10/598,086

Hiroshi Kawazoe

Office Action Summary	Application No. 10/598,086	Applicant(s) KAWAZOE ET AL.	
	Examiner Jan M. Ludlow	Art Unit 1797

Fig.3

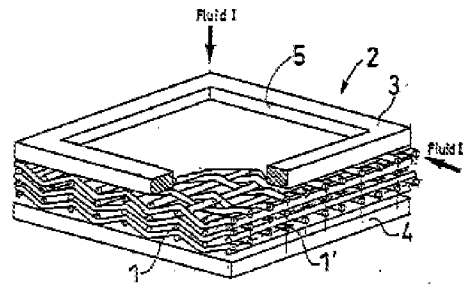
6. With respect to claim 4, Durst et al. teaches at least one capillary hollow fiber (1) (hollow filament) is placed crosswise to at least another capillary hollow fiber (1) (hollow filament; placed crosswise the capillary hollow fiber (1) (hollow filament) itself (fig. 1, fig. 3).

3. With respect to claim 4, the fibers are shown as woven in Fig. 3, and therefore cross each other.

Fig.4

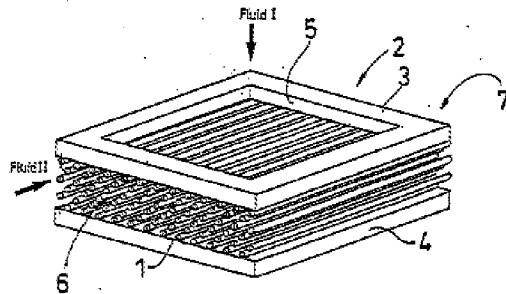
10. With respect to claim 9, Durst et al. teaches the inlet and discharge opening (5) (port) is fixed to (at least one of) the upper frame part (first and second supporting plates). See, e.g. Fig. 4.
